PLANT NAME: Oconee Units 1-2-3

Response to NRC request for additional info. concerning the fire protection program.....w/att set of drawings...

Reference: Oconee Nuclear Station  
Docket Nos. 50-269, -270, -287

RESPONSE TO  
REQUESTS FOR ADDITIONAL INFORMATION  
OCONEE UNITS 1, 2, AND 3  
FIRE PROTECTION

ATTACHMENT I

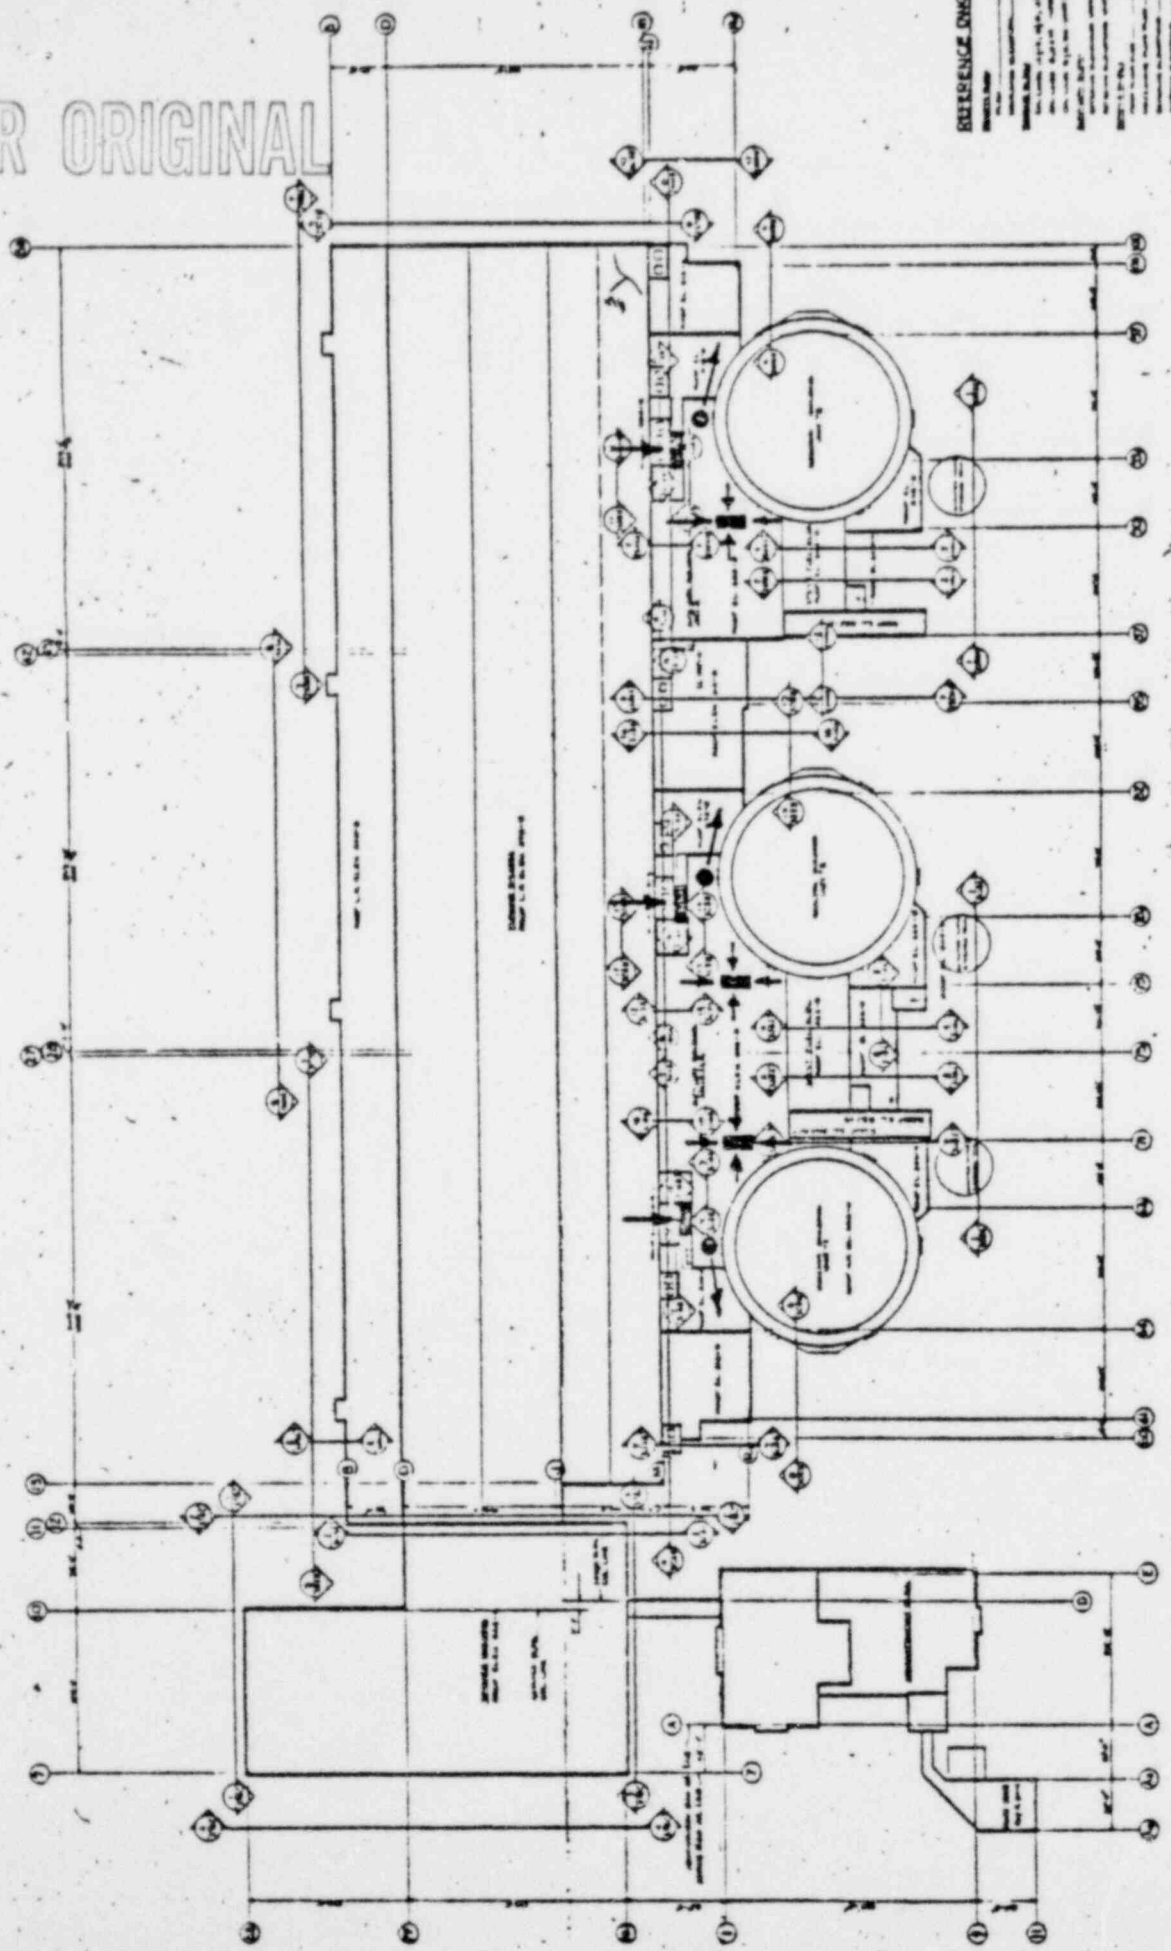
Identify the location of ventilation air intake and exhaust openings and describe the potential for smoke being drawn into air intakes after being exhausted from another area.

The closest ventilation air intake is approximately 12 feet horizontally and 145 feet vertically from the unit vent. All exhaust from the Auxiliary Building is routed to the unit vent. Any products of combustion from a fire would be well diluted by exhaust taken from other areas of the Auxiliary Building prior to reaching the unit vent. The exit velocity from the unit vent is approximately 3900 fpm which would tend to make it unlikely that smoke would be drawn into the intake. Thus the separation and exit velocity combine to minimize the occurrence of such an event. The proximity of turbine building exhaust to the nearest Auxiliary Building air intake is approximately 12 feet horizontally and 7 feet vertically. The turbine exhaust is above this intake and fans of the upblast type are utilized. The fan exit velocity is approximately 2400 fpm, therefore, the location and the exit velocity would tend to preclude the potential for combustion products being drawn into the Auxiliary Building intake. See attachment No. 1 for the auxiliary intake and exhaust arrangement.
